TRANS/WP.15/178  
29 March 2004

**EUROPEAN AGREEMENT CONCERNING THE INTERNATIONAL CARRIAGE OF  
DANGEROUS GOODS BY ROAD (ADR)**

**Draft amendments to annexes A and B of ADR**

**Note by the secretariat**

**Figure 2.3.6: Flowchart scheme for the classification of organometallic substances in Classes 4.2 and 4.3<sup>b</sup>**

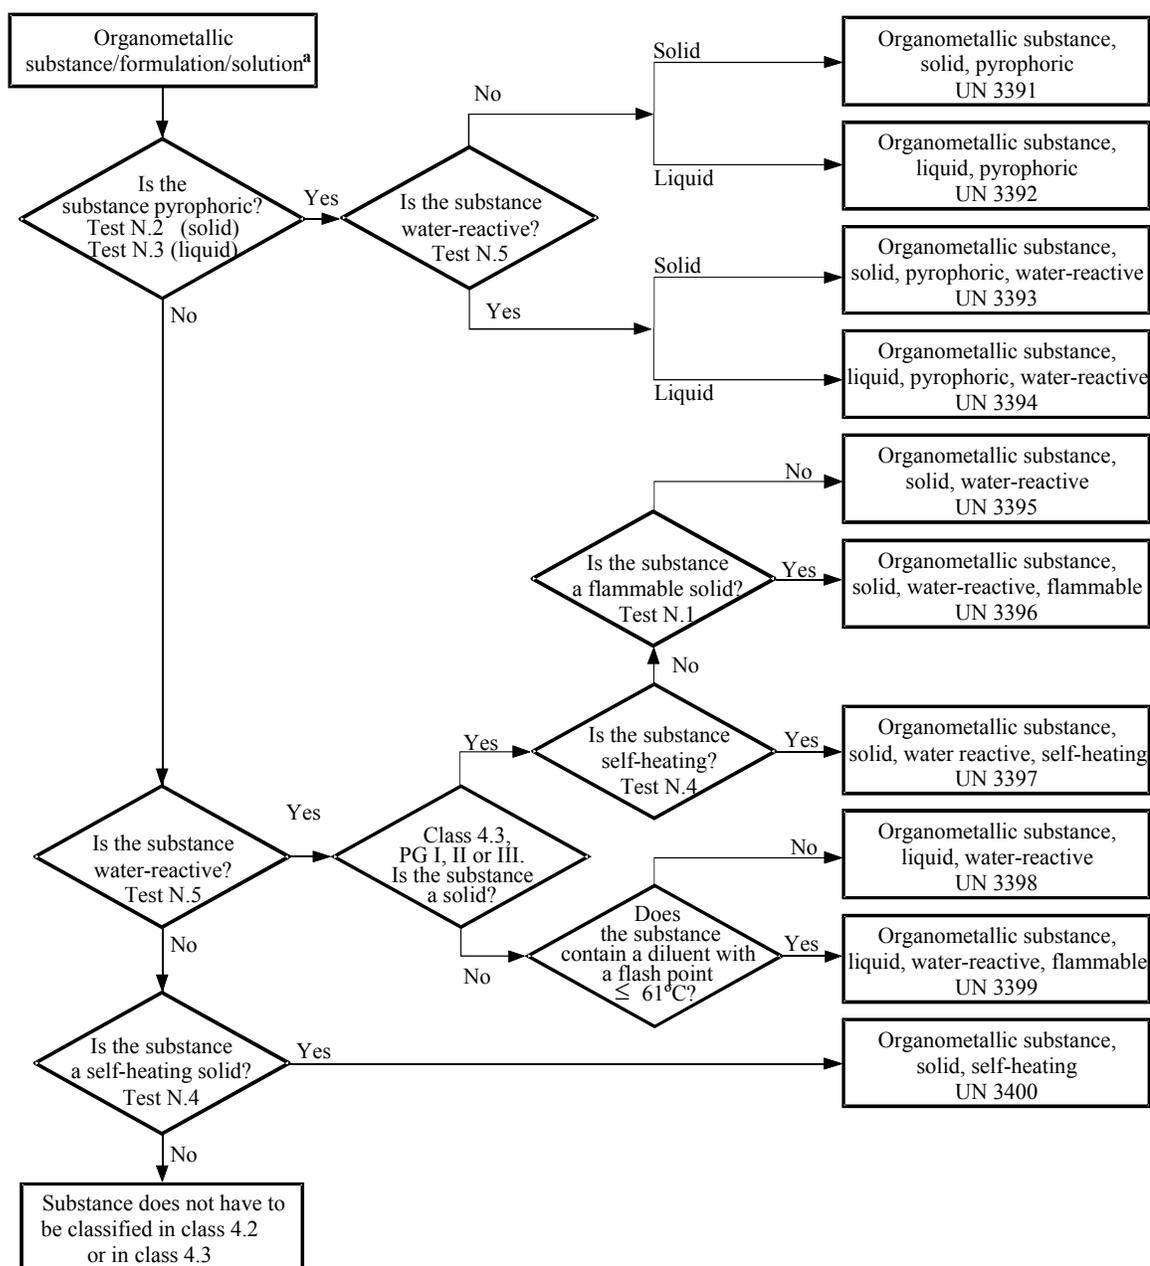
2.3.6 Add a new paragraph and a new figure 2.3.6 as follows:

Depending on their properties as determined in accordance with tests N.1 to N.5 of the Manual of Tests and Criteria, Part III, section 33, organometallic substances may be classified in Class 4.2 or 4.3, as appropriate, in accordance with the flowchart scheme given in Figure 2.3.6.

**Figure 4.1.1.19.1: Scheme for the assimilation of filling substances to standard liquids**

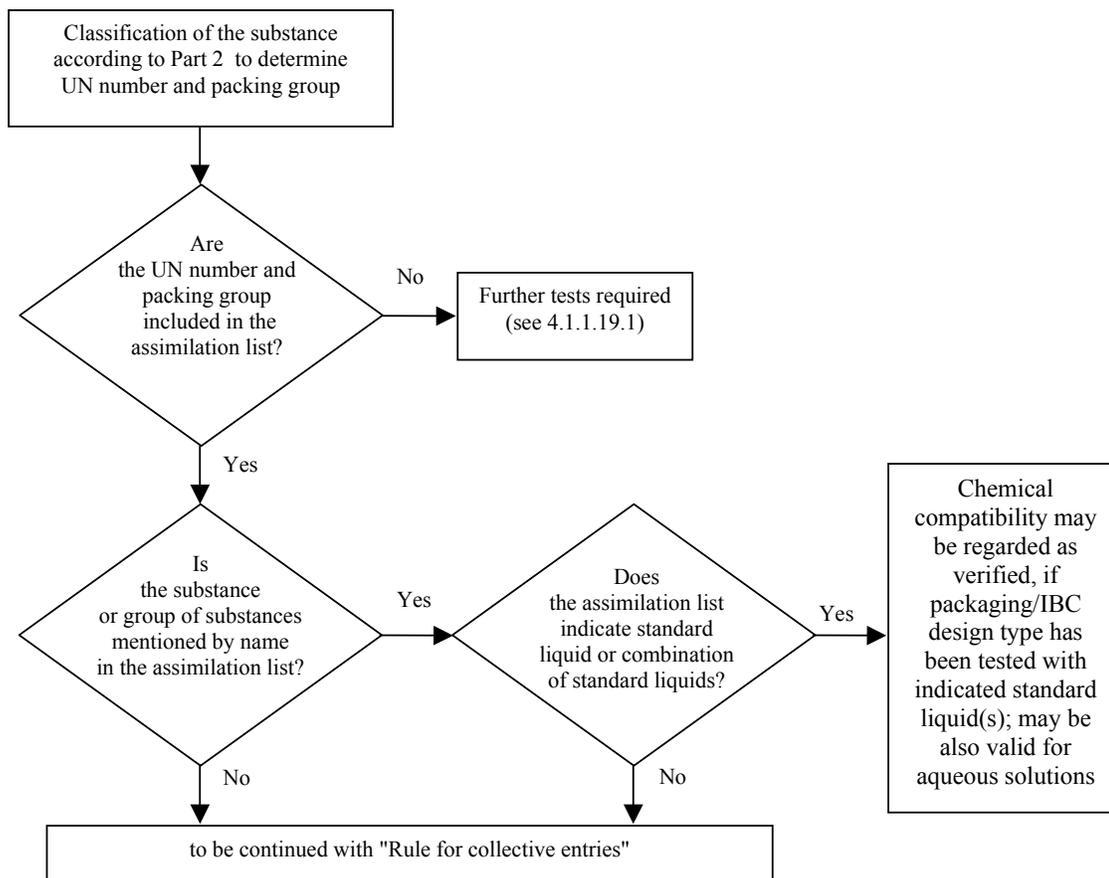
The following steps shall be taken to assign filling substances to listed substances or groups of substances in table 4.1.1.19.6 (see also scheme in Figure 4.1.1.19.1):

**Figure 4.1.1.19.2: Scheme "Rules for collective entries"**

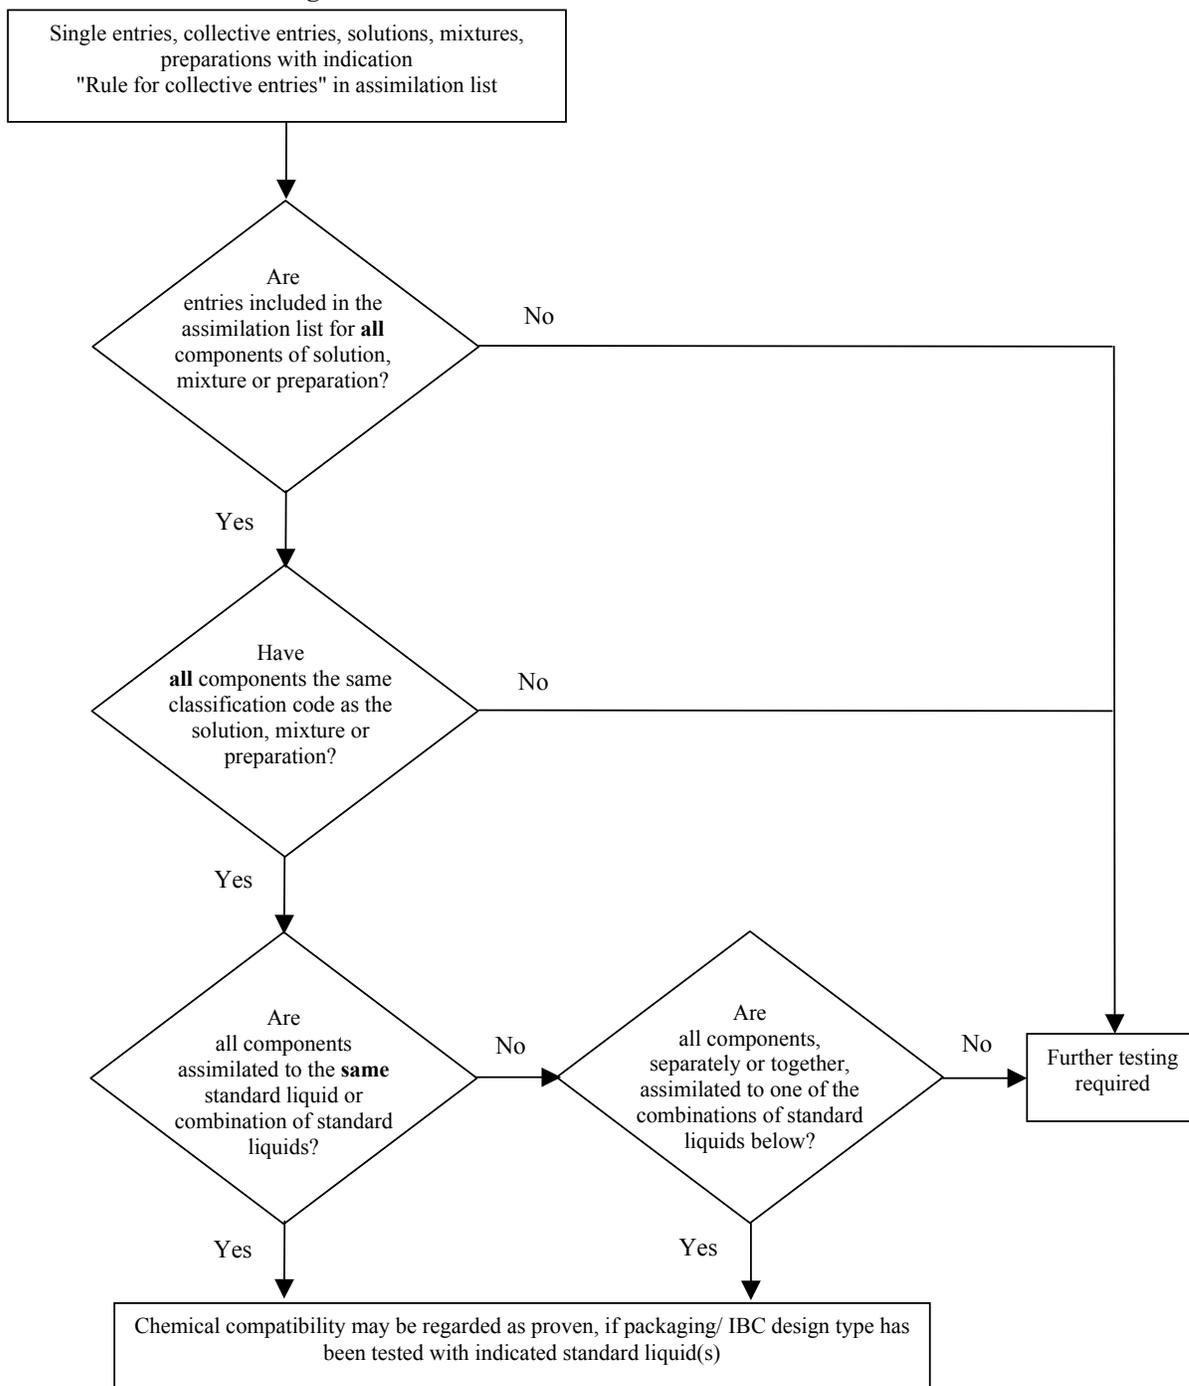
For the assimilation of filling substances for which "Rule for collective entries" is indicated in column (5), the following steps shall be taken and conditions be met (see also scheme in Figure 4.1.1.19.2):
